Re: Parkview at Alvarado Apartments Addition Preliminary Plat

This letter is to inform you that on May 9, 2023, the Alvarado Planning and Zoning Commission recommended disapproval of the preliminary plat for the Parkview at Alvarado Apartments Addition due to the following reasons in red and blue. Informational comments not requiring action on the preliminary plat are noted as so below.

PRELIMINARY PLAT
PARKVIEW AT ALVARADO APARTMENTS
LOTS 1 THRU 6, BLOCK A
29.021 ACRES (1,263,760 SQ.FT.)
IRA GLAZE SURVEY, ABSTRACT 313
ALVARADO, JOHNSON COUNTY, TEXAS
PREPARED: MARCH 29, 2023

City Engineer Remarks on Preliminary Plat Copy

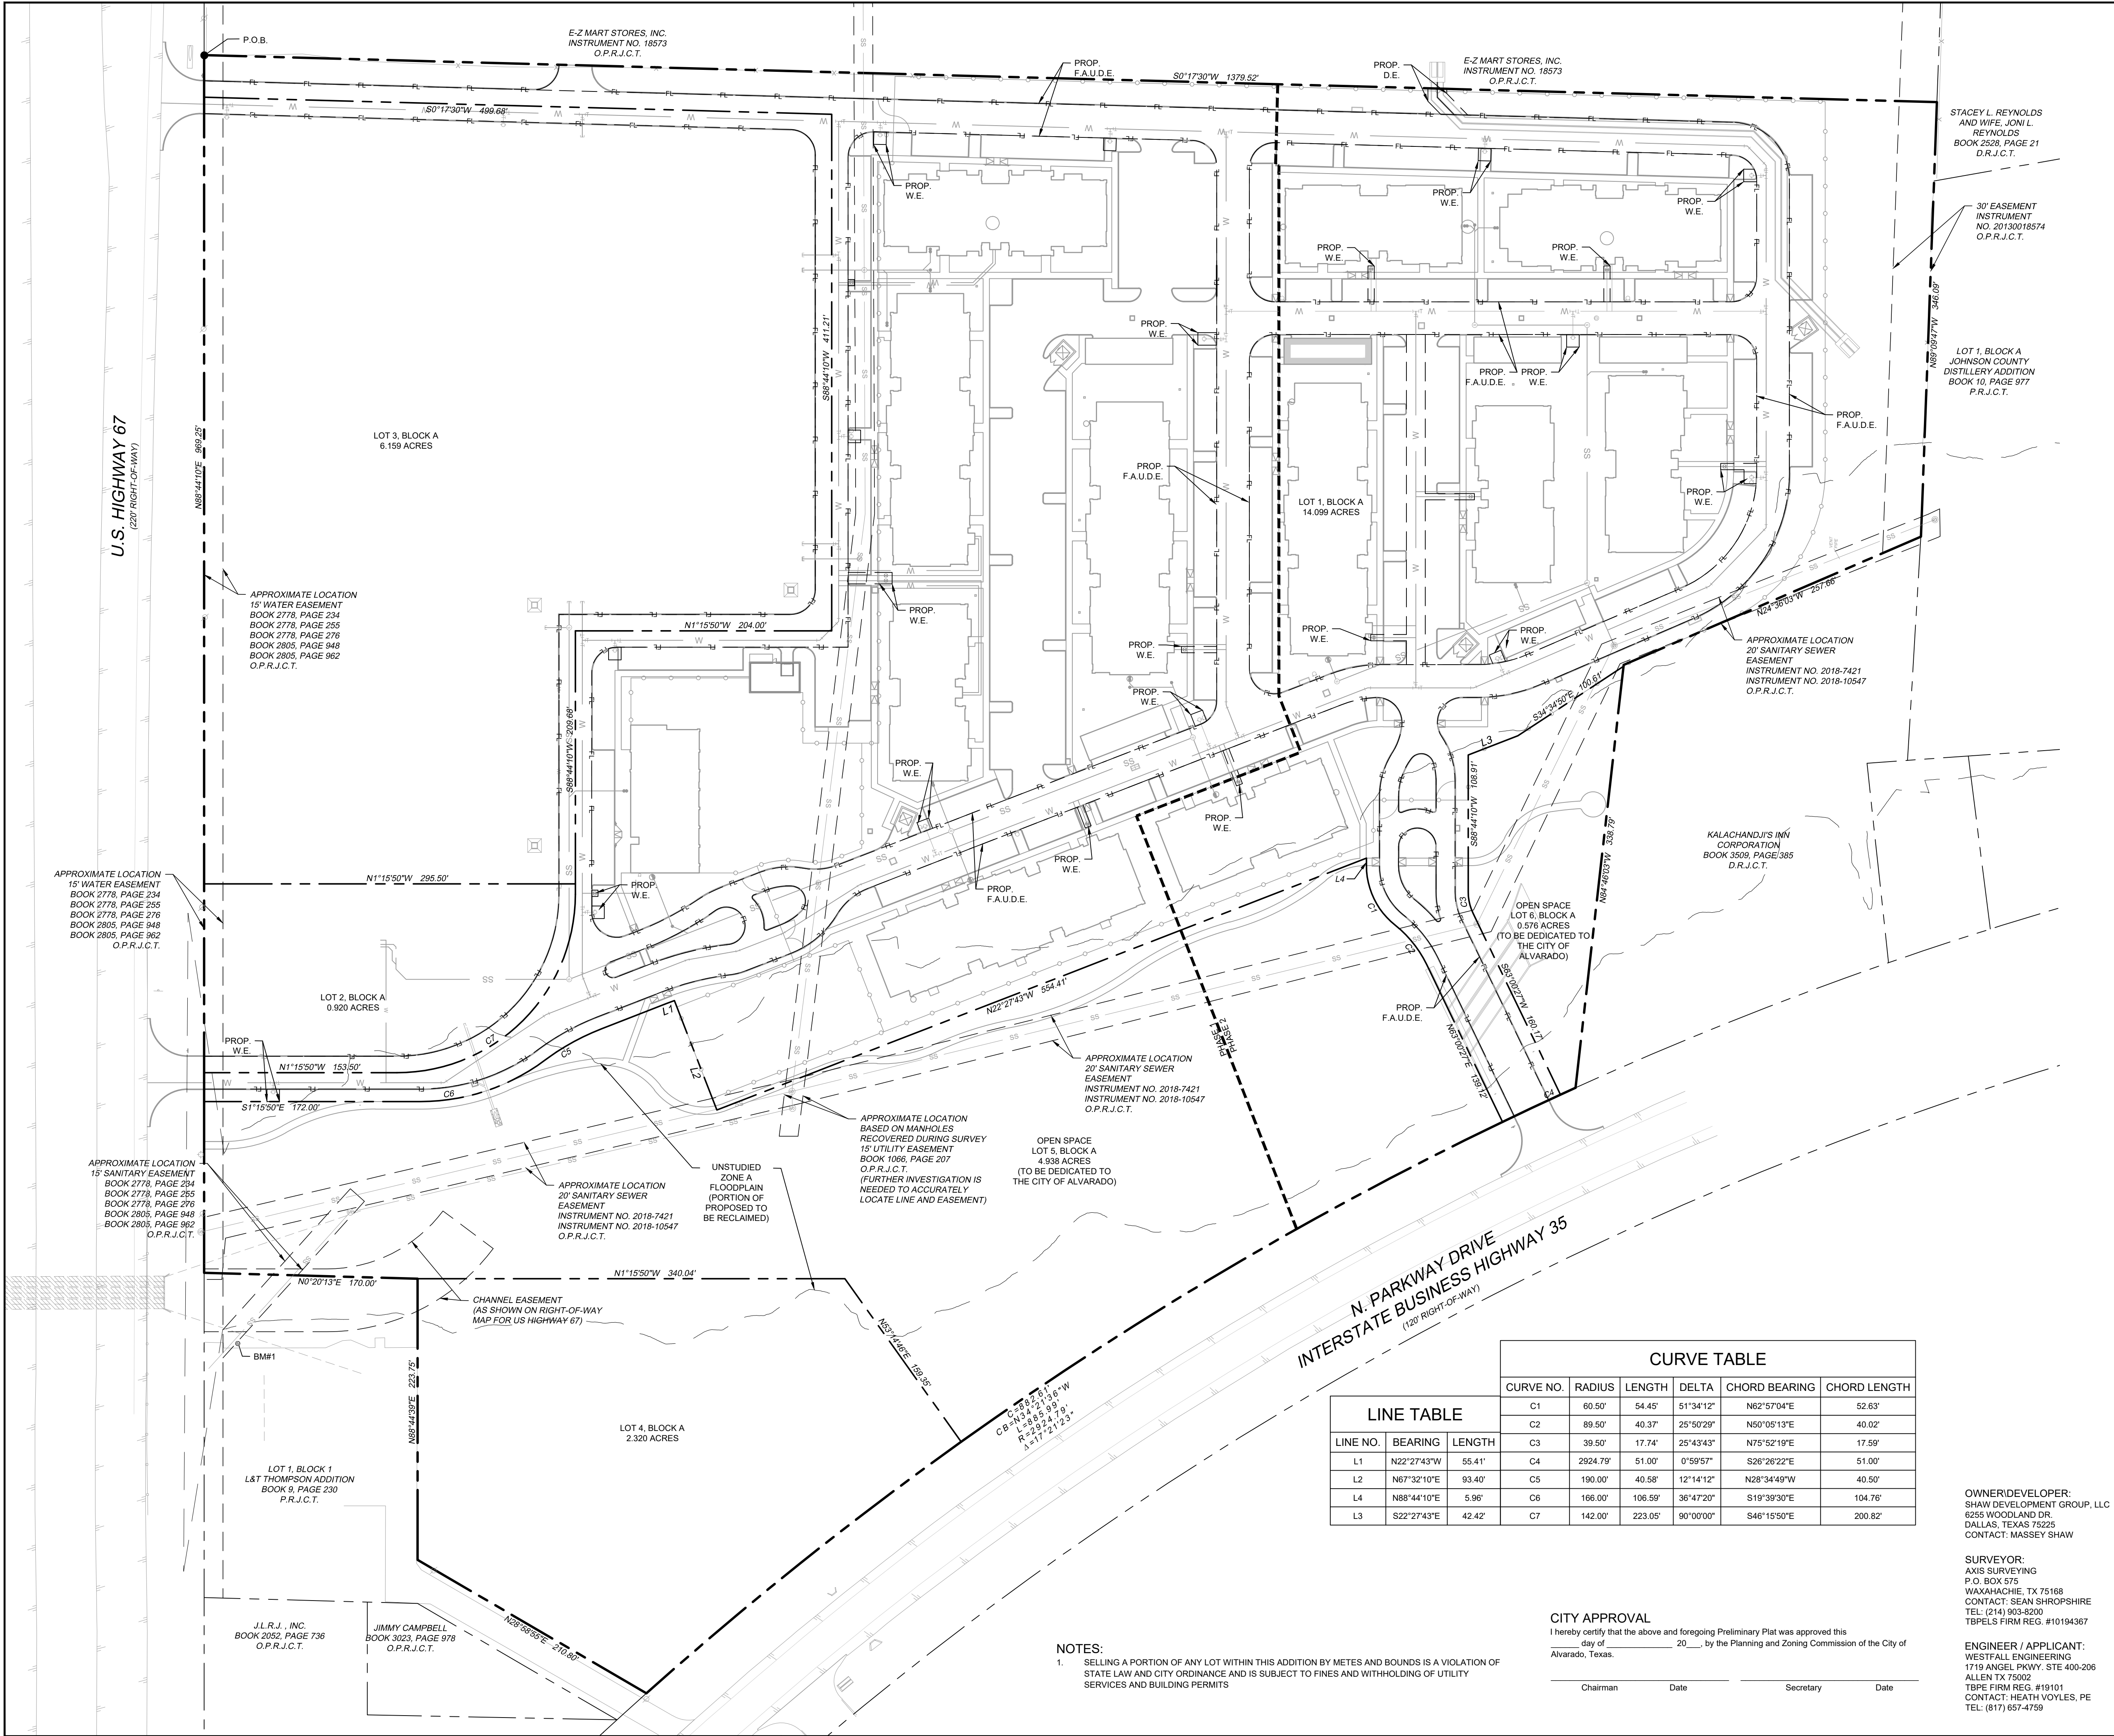
2. Per Sec. 34-170 of the Alvarado subdivision ordinance (a) the size of easements where alleys are not provided must not be less than ten feet on each side of rear lot lines. Easements alongside lot lines must be not less than ten feet in width. However, while deemed necessary by the Planning and Zoning Commission and/or the City Council, such easements may be required to be 20 feet in width, (b) where necessary, easements must be retained for poles, wires, conduits, storm sewers, sanitary sewers, water lines, open drains, gas lines or other utilities. Such easements may be required across parts of lots (including side lines) other than as described above if the City Council determines that same is needed. Any easements so established shall be maintained by the property owner. **On the revised preliminary plat, show a 20-foot utility easement along the plat's frontage to N. Parkway Drive for future utilities.**

4. On the revised preliminary plat, the easements and legend referencing F.A.U.D.E. and F.A.D.U.E shall be corrected throughout the plat and F.L. must be added to the legend unless changed to an acronym already in legend.

5. On the revised preliminary plat, the City approval block shall be removed from the preliminary plat.
6. On the revised preliminary plat show the apartment building addresses for easier referencing through the project's review and once ready for addressing contact Johnson County.

7. On the revised preliminary plat, clarify or remove the dashed lines along Hwy 67 near and between Lot 1, Block 1 of L&T Thompson Addition and proposed Lot 2, Block A.

8. On the revised preliminary plat, note the purpose of the 30' Easement dedicated by instrument no. 20130018574 along the southern property line.
9. Informational comment – location of pedestrian gates shall be clarified in the development plan.

10. Lots 5 and 6 must be included in the final plat submittal for Lot 1.
11. Access to N. Parkway Drive must be constructed and pass City inspection prior to any building permits for vertical construction in Phase 2.

15. Provide water demand for the development so access to adequate water may be determined.
16. Only one water main is shown on the preliminary plat. The developer must provide a water main for fire suppression only. Two separate water mains are required (a domestic main and fire main).

20. A water line is shown on proposed Lot 2, Block A and is not within an easement. Clarify if this water line is existing and to remain, proposed to be abandoned, or proposed. Provide easement as necessary.
21. Water lines are shown between the northern three apartment buildings in Phase 1 that must be clarified and placed within a water easement if a water main.
22. Clarify how proposed Lot 4, Block A will have adequate access to water services. Record maps show a 12" water main at the southern corner of the Alvarado Pharmacy site (Lot 1, Block 1 of the McAnally Estates Addition). A 10' U.E. was dedicated along this lot's frontage to N. Parkway Drive. Consider boring under N. Parkway Drive for services in front of proposed Lot 4, Block A.

28. A sanitary sewer line is shown on proposed Lot 2, Block A and is not within an easement. Clarify if this sanitary sewer line is existing and to remain, proposed to be abandoned, or proposed. Provide easement as necessary.

29. A sanitary sewer line is shown between the two southern apartment buildings with east/west orientation that must be clarified if private plumbing yard line or a sanitary sewer main to be

within a sanitary sewer easement not shown. Another sanitary sewer line is shown similarly on the west side of the middle apartment buildings in Phase 2 that must be clarified.

30. Map records show the 8" sanitary sewer main within the 15' U.E. in Book 1066, Page 207 on proposed Lots 1 and 5 to continue west and cross N. Parkway Drive. Therefore, this main must be located and a 15' U.E. or S.S.E. must be dedicated on proposed Lots 4 and 5 as necessary.

32. To increase traffic safety and efficiency, drive approaches on N. Parkway Drive shall be limited and to facilitate this a dedication of a 24-foot-wide **private access easement** along N. Parkway Drive right-of-way (offset at least 18 feet) traversing from the N. Parkway Drive entrance to Lot 1, Block 1 of the L&T Thompson Addition will satisfy this comment. (Reference Sec. 34-176 of the Alvarado subdivision ordinance).

33. It was presented to the City that cross access between proposed Lots 1-3 and the EZ Mart property is provided by showing a fire lane on the plat; however, fire lanes may be gated as is evident on proposed Lot 1. Therefore, on the revised preliminary plat show a **private access easement** provide cross connectivity between at least Lots 1, 3, and the EZ Mart property. Then provide a note on the revised preliminary plat stating who the private access easement serves.

36. Per Section 34-65(1)e of the Alvarado subdivision ordinance, the preliminary plat must contain **topographical information** with contour lines at one-foot intervals and all elevations must be referred to a geodetic survey.

40. Prior to submittal of the final plat, the offsite drainage facilities shown on the property to the east owned by EZ Mart must be located within a drainage easement obtained from EZ Mart and recorded by separate instrument with the Johnson County Clerk's office. Note the instrument number and drainage easement on the final plat submittal.

41. On the final plat submittal for Lot 1, the drainage plan must adequately account for the stormwater conveyance from the EZ Mart property. The City may wish to partner in the oversizing of drainage facilities to prevent onsite detention once the EZ Mart property develops.

42. On the final plat submittal, the entire drainage facilities described in above must be located within a drainage easement of adequate width.
43. Similarly, on the final plat submittal, the drainage facility shown on proposed Lot 2, Block A crosses Lot 1 discharges on Lot 5 and must be located entirely within a drainage easement of adequate width.

44. Clarify what appears to graphically be three drop inlets on proposed Lot 3, and if they are drop inlets clarify where by what the stormwater will be conveyed. Additional drainage easement(s) may be required on Lots 1 and 2 to prevent the necessity of onsite detention ponds on Lot 3.

45. Prior to the submittal of the first final plat, a detailed **flood study** is needed to establish floodway, 1% chance floodplain limits and Base Flood Elevations. (Reference the Flood Hazard Reduction ordinance, Chapter 18 of the Alvarado Code of Ordinances). Per Chapter 245 of the Texas Local Government Code, this project is vested under the Flood Hazard Reduction Ordinance pre-dating the April 17th amendments.
46. Informational comment - Per Sec. 34-128(b) of the Alvarado subdivision ordinance, areas subject to flood conditions as established by the federal insurance administrator will not be considered for development until both adequate drainage and elevation of lots, streets, and alleys have been accomplished to meet the requirements of the floodplain map.

- a. Floodplain and natural drainage areas should not exceed 75 percent of the total park site. On a revised preliminary plat, provide a table showing the percentage of parkland dedication within floodplain.

49. Per Sec. 34-91(2)a.6 of the Alvarado subdivision ordinance, proposed boundaries of park dedications will provide reasonable access to improved street frontage for readily accessible entry into the park area by the public, and per Sec. 34.91(2)b, each park must have access to a public street. Dedication of a 24-foot-wide private access easement from the N. Parkway Drive entrance to Lot 1, Block 1 of the L&T Thompson Addition will satisfy this comment.

52. Clarify on the preliminary plat if the dog park, pool area, sand volleyball/bocce ball, and pickleball/sports court shown on the Council-approved concept plan are still proposed for the

apartment residents and if credit toward parkland dedication requirements is sought for their construction.
